**Broken Hill BESS: Battery Storage Facility (Stage 1) Heritage
Management Plan**

Project Name	Broken Hill BESS: Battery Storage Facility (Stage 1) Heritage Management Plan
Project Number	22COF2207
Project Manager	Matthew Finlayson
Prepared by	Mathew Finlayson
Reviewed by	Tim Hill
Approved by	Tim Hill
Status	Final
Version Number	V2c
Last saved on	1 July 2022

Appendix 3: Cultural Heritage Constraints (AECOM 2022)

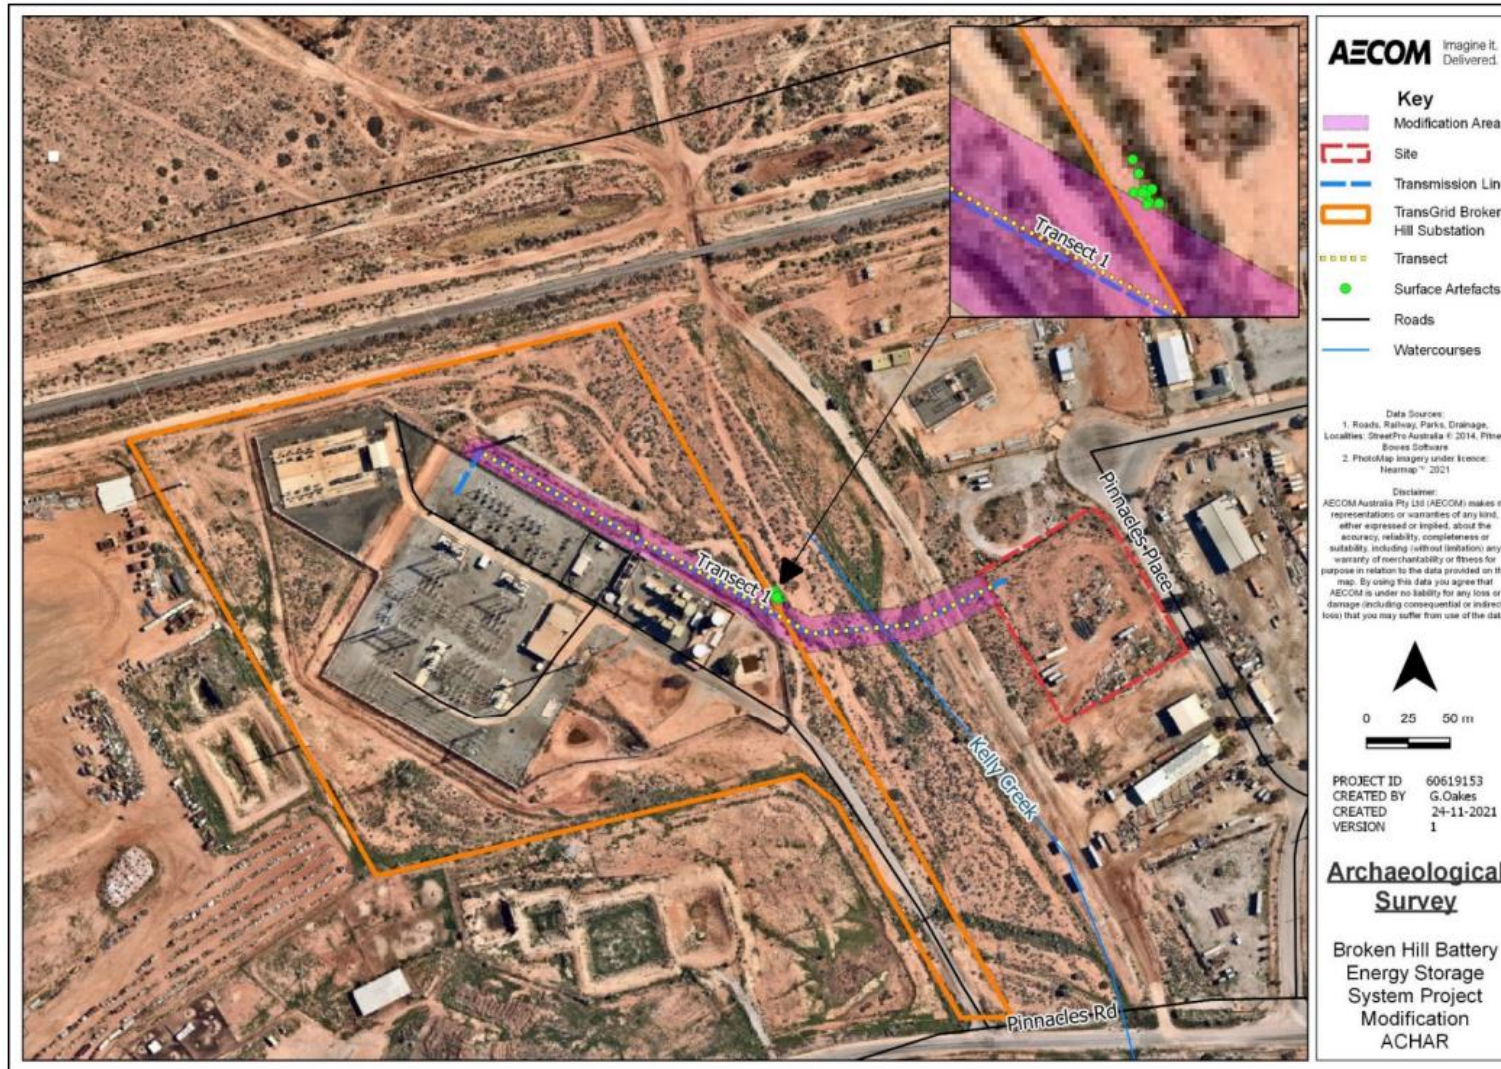
1. 2.2 Plan Development – 4 RAPs but consultation with 3 only (Cally Doyle not included) ?
2. 2.3.2 High Voltage Power Easement – Avoidance, no specific mgt measures provided in AHMP. Please ensure site is mapped in CEMP (or similar), exclusion fencing (if appropriate with RAPs) and included in inductions (& tool box meetings) as an exclusion zone.

1. 2.5 Who is delivering the “Cultural Site Inductions” – who approves content, & does a “pre works survey with RAPs to confirm the extent of the archaeological site” value add ? Surely the site has been assessed, excavated/salvaged and mapped sufficiently for safeguard. Maybe ask RAPs to visit pre works to confirm exclusion fencing appropriately placed, or ask RAPs to participate in exclusion fencing installation. Not sure of the objective.

Given the location of the known artefacts the Heritage Management Plan considers that the site can be substantially avoided by the implementation of design and construction amendments. The primary mitigation measures for the known extent of the site (See Appendix 3) include:

In accordance with the AECOM Modification ACHAR all stone artefacts within the approved development footprint shall be relocated into the BESS-AS-21 site extent (see Appendix 3). At the completion of the relocation an Aboriginal Site Impact Recording Form (ASIRF) shall be submitted to the Aboriginal Heritage Information Management System (AHIMS) to provide a primary document of the relocation of artefacts.
